Subarunet Announcement

Subject: New Service Program: WTI-69 Vehicle Emission Control Information (VECI) Labels

Subaru Service Program WTI-69
September 2016

Instructions for Customer completion of Subaru Service Campaign WTI-69: Vehicle Emission Control Instruction (VECI) label replacement

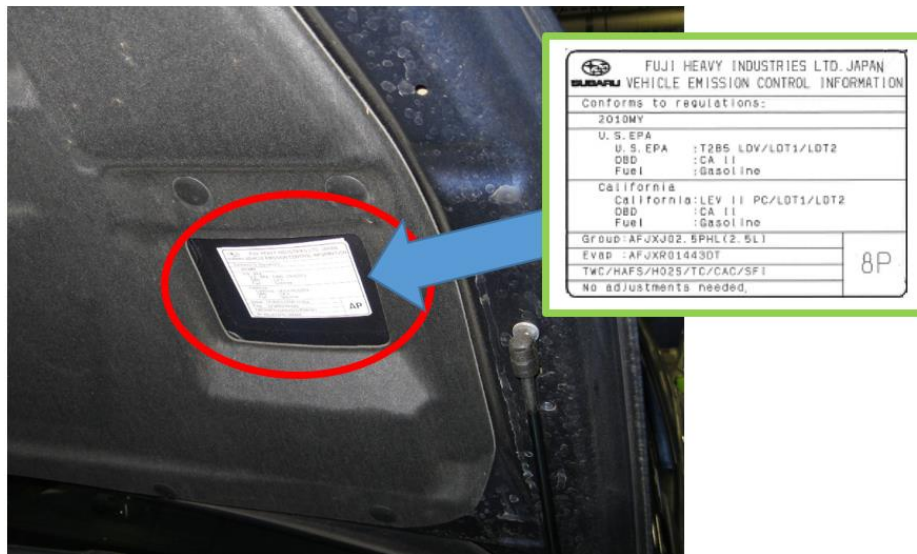
Step 3: Locate the existing VECI label on the driver’s side of the under hood panel as shown below.

Step 4: Use a clean, dry cloth to wipe any dirt or grease from the surface of the original label. **DO NOT** attempt to peel off the original label.

Step 5: Peel the backing of the new **BLANK** label and apply it first, directly over the original. This will ensure the printing from the original label cannot be seen through the new label.

Step 7: Peel the backing of the new VECI label and apply it directly over the newly-installed blank label.
